ATS & PSFP YANG maintenance items #0392 & #0393 Updates 802.1 Jul Plenary

Maintenance items

- #0392

- #0393

Figure 48-16—Asynchronous Traffic Shaping model

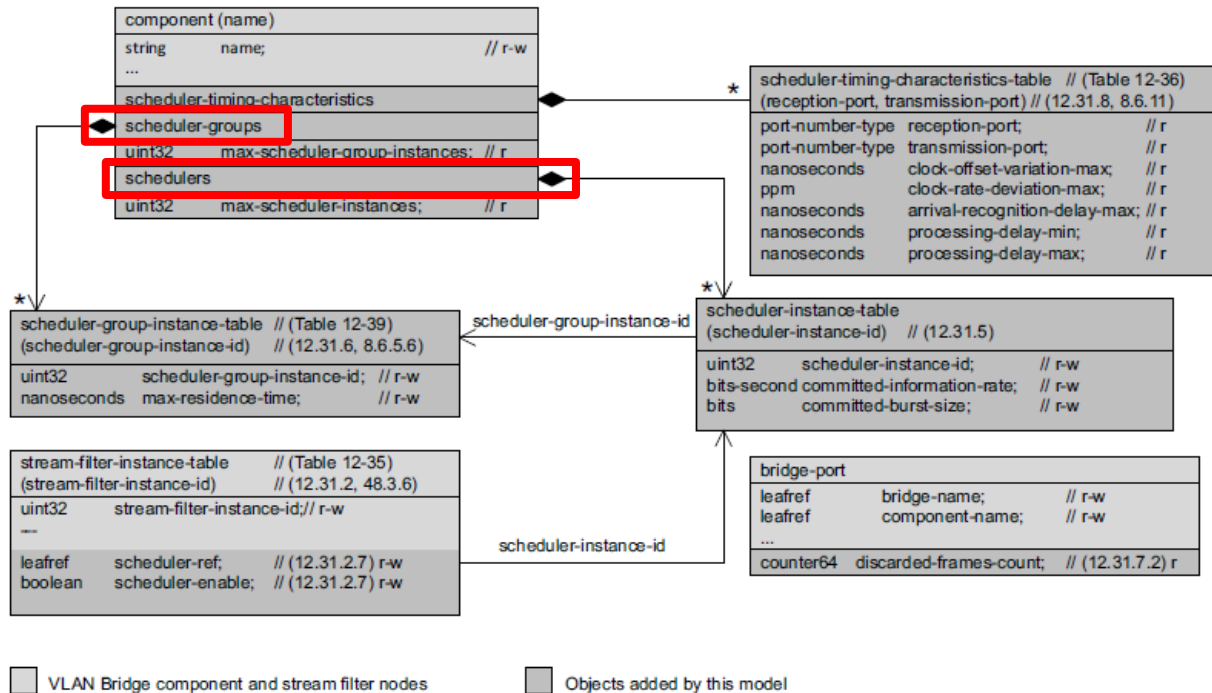
- The latest revision 2023-07-03 doesn't align with 802.1Q
 - *ats:ats-parameters* is under augment of “stream-filters/stream-filter-instance-table”
 - It creates multiple ***the Scheduler Instance Table (12.31.5)*** and ***the Scheduler Group Instance Table (12.31.6)*** under ***the Stream Filter Instance Table (12.31.2)*** than one per the Bridge Component.

- No change on `ieee802-dot1q-ats.yang`
- Modified `ieee802-dot1q-ats-bridge.yang`
 - Move *ats:ats-parameters*
 - from under of *augment "stream-filters/stream-filter-instance-table"*
 - to under *augment "/dot1q:bridges/dot1q:bridge/dot1q:component"*
 - It creates ***single Scheduler Instance Table (12.31.5)*** and ***single Scheduler Group Instance Table (12.31.6)*** under the Bridge Component.

802.1Q-2022-Rev ATS/PSFP/CI YANG schema

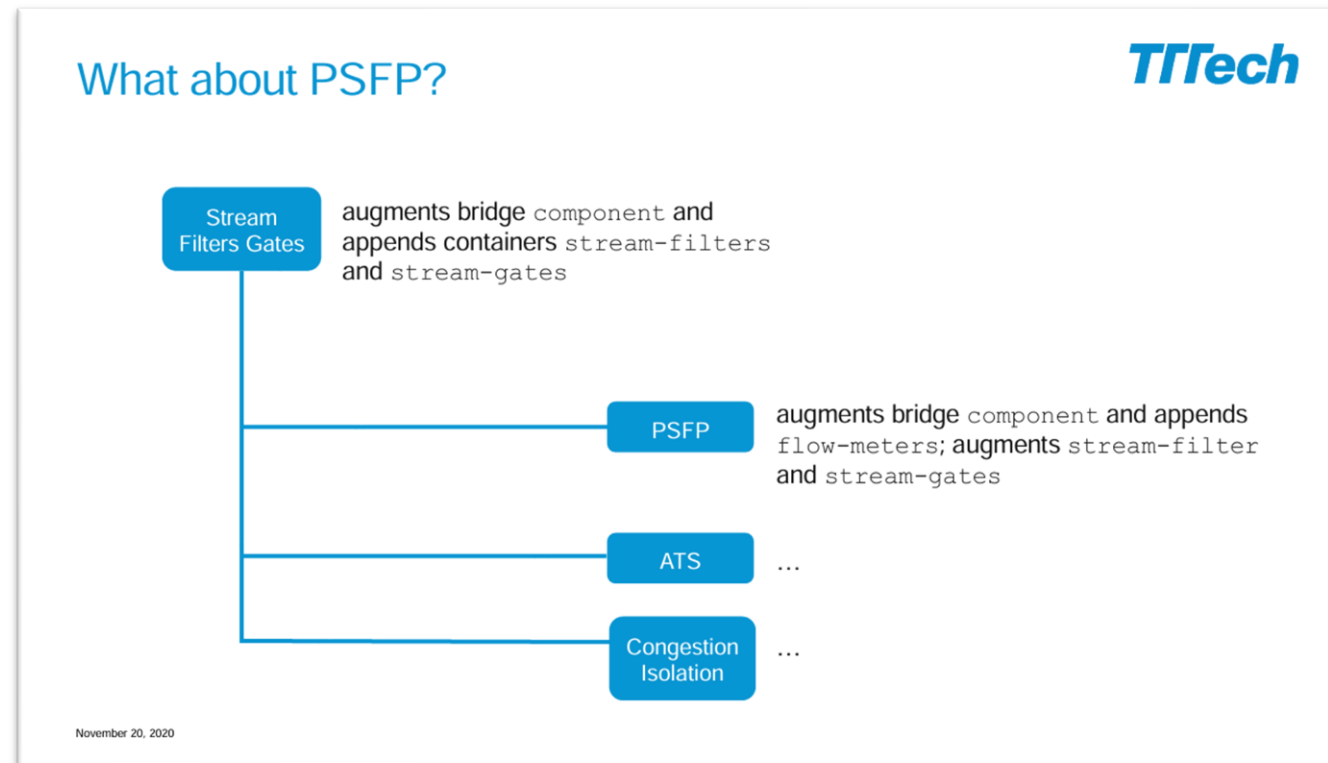
- Define “*grouping sfsg-parameters*” in ieee802-dot1q-stream-filters-gates.yang
- Uses “*uses sfsg:sfsg-parameters*” in 3 modules of ieee802-dot1q-[ats/psfp/congestion-isolation]-bridge.yang

- **Problem**

- “*Uses*” statement copies the nodes defined by the “*grouping*” into the current schema tree.
- This creates **own Stream Filter and Stream Gate of each module** under the bridge component.

- **Removing “use sfsg:sfsg-parameters” in**
 - ...ats-bridge.yang, ...psfp-bridge.yang (i.e., ...pspf.yang) and ...congestion-isolation-bridge (i.e., ..congestion-isolation.yang)
 - ...ats-if.yang, & ...psfp-sys.yang
- **Use a base modules**
 - **ieee802-dot1q-streams-filters-gates-bridges.yang** for bridge functions
 - for bridge (802.1Q) : sfsg-bridge
 - **ieee802-dot1dc-streams-filters-gates-sys.yang** for system functions
 - for system (802.1DC) : sfsg-sys
- **Each module augment into base node created by base modules**
 - sfsg-bridge
 - ats-bridge
 - psfp-bridge
 - ci-bridge

sfsg:sfsg-parameters reference analysis

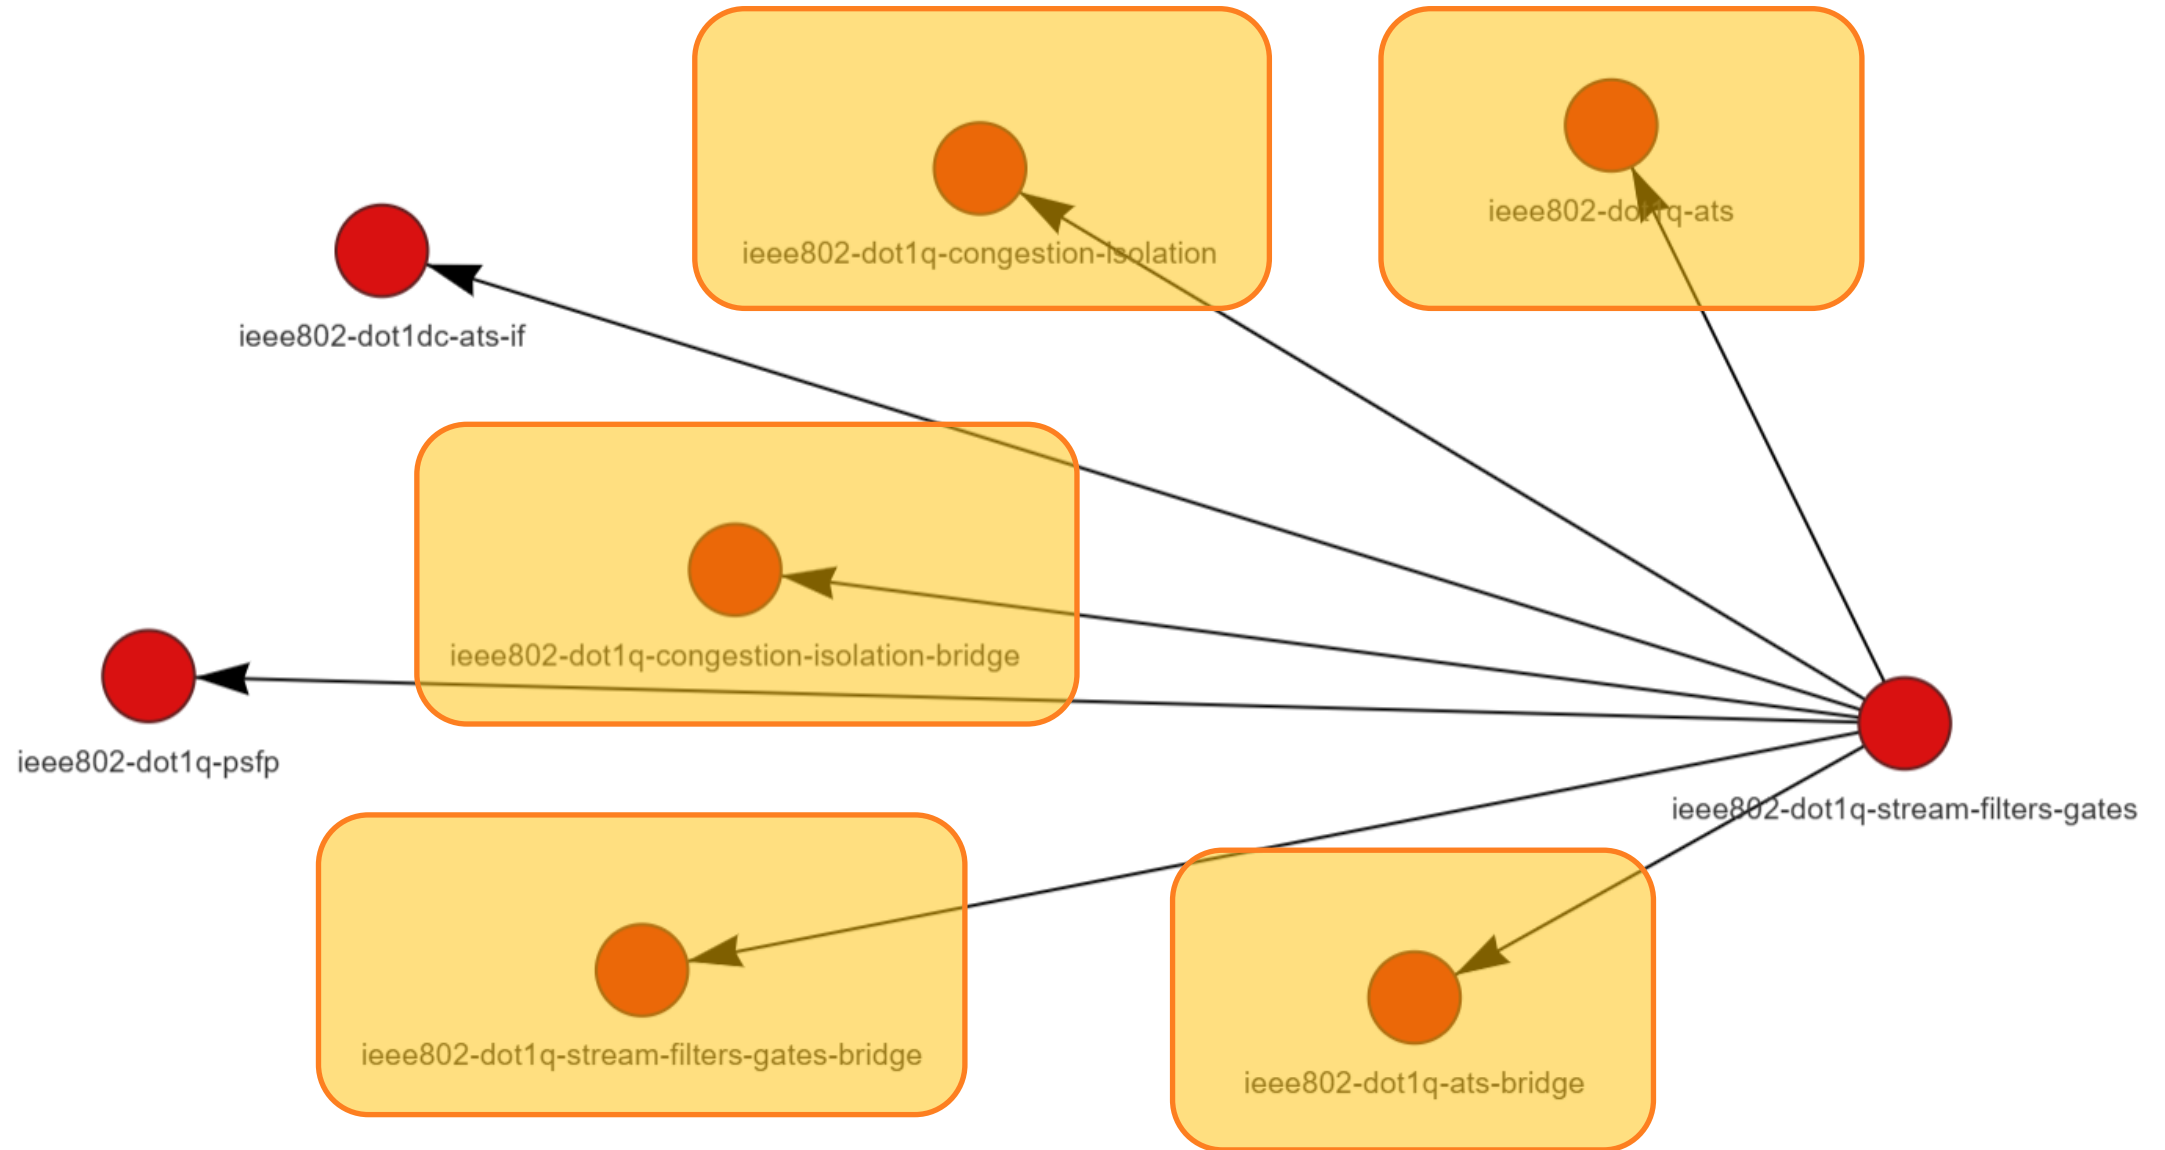
- **Problem**

- “*Uses*” statement copies the nodes defined by the “*grouping*” into the current schema tree.
- This creates **own Stream Filter and Stream Gate of each module** under the bridge component.

sfsg:sfsg-parameters reference analysis

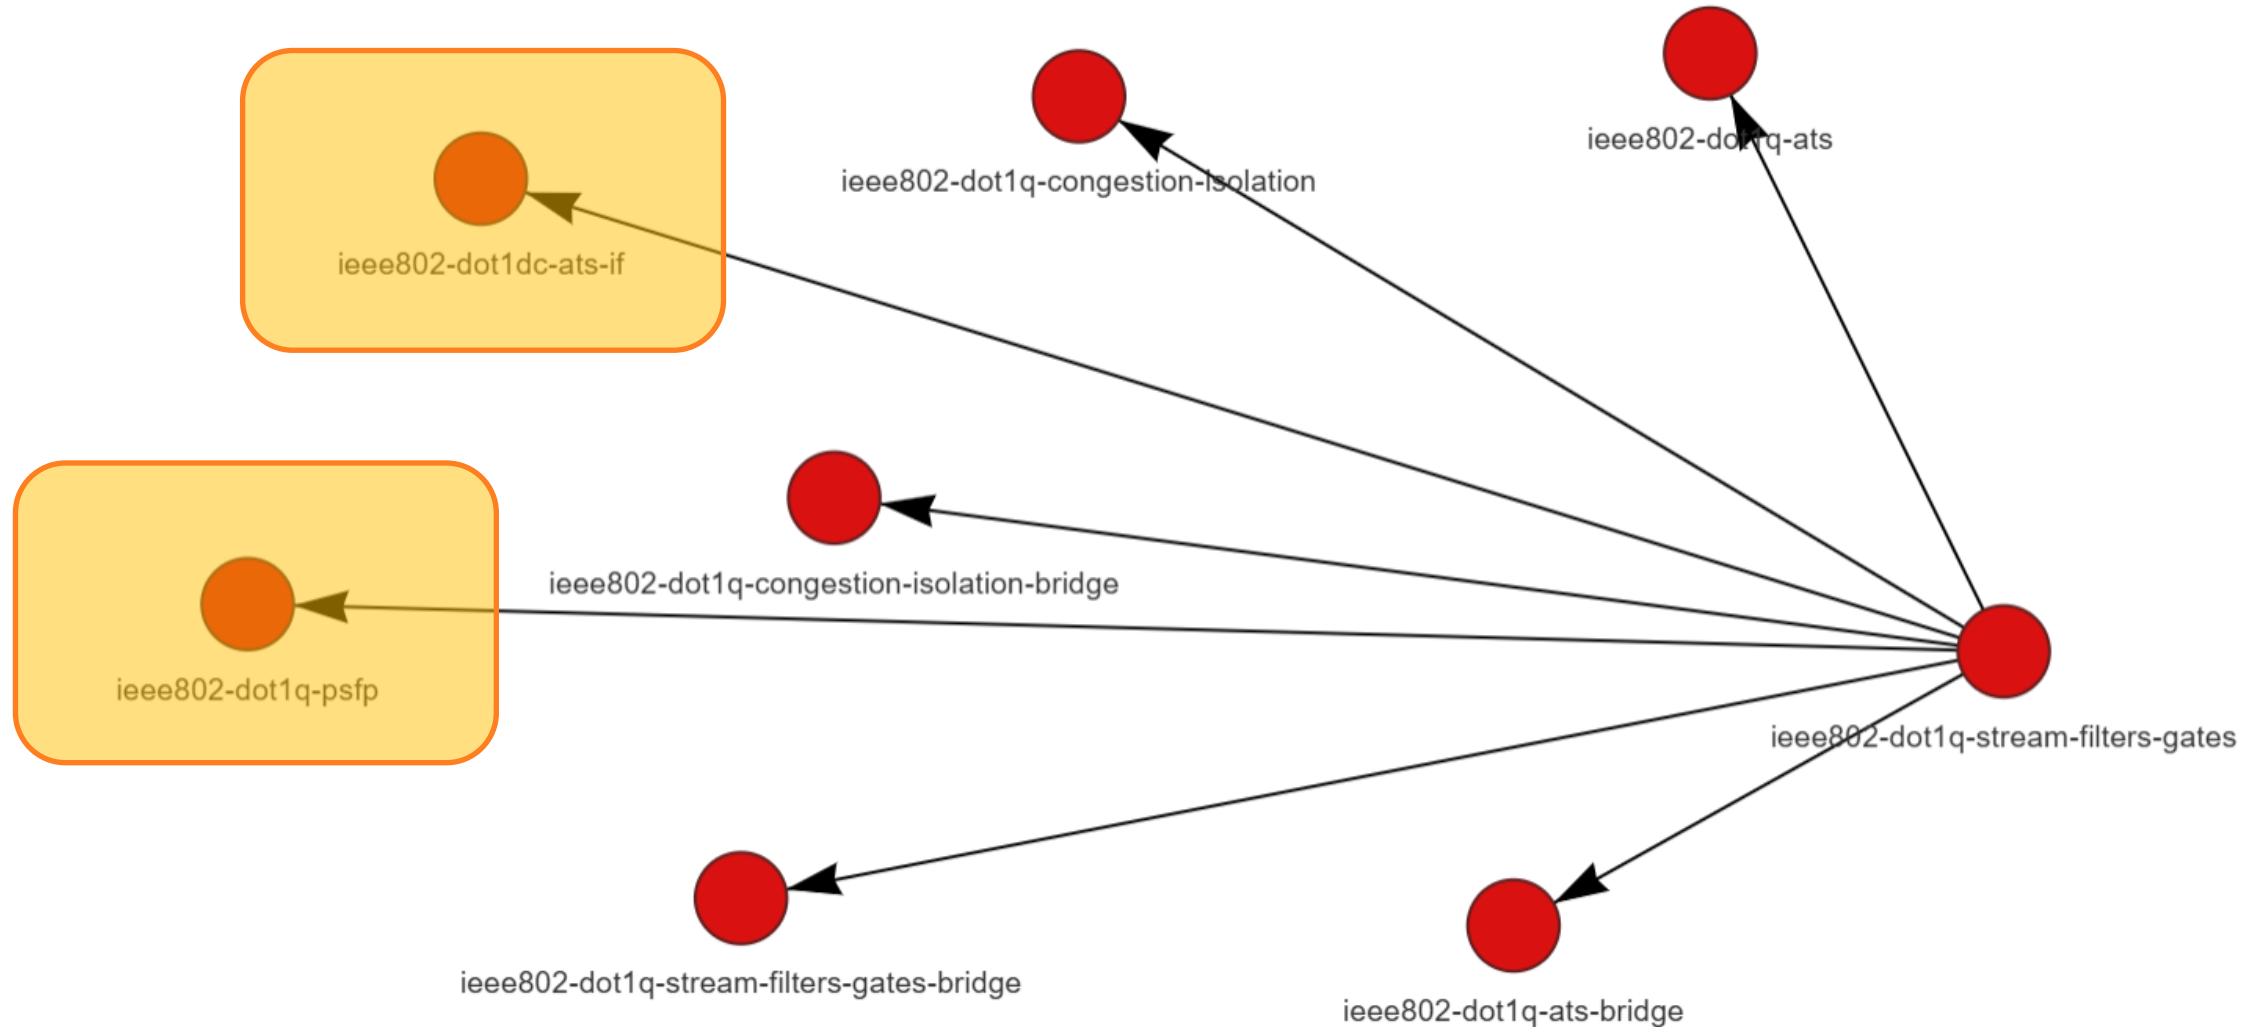
- Define “*grouping sfsg-parameters*” in ieee802-dot1q-stream-filters-gates.yang
- Uses “*uses sfsg:sfsg-parameters*” in ieee802-dot1dc-psfp-sys.yang (from ieee802-dot1q-psfp.yang) and ieee802-dot1dc-ats-if.yang

- **Problem**

- “*Uses*” statement copies the nodes defined by the “*grouping*” into the current schema tree.
- This creates **own Stream Filter and Stream Gate of each module** under the bridge component.
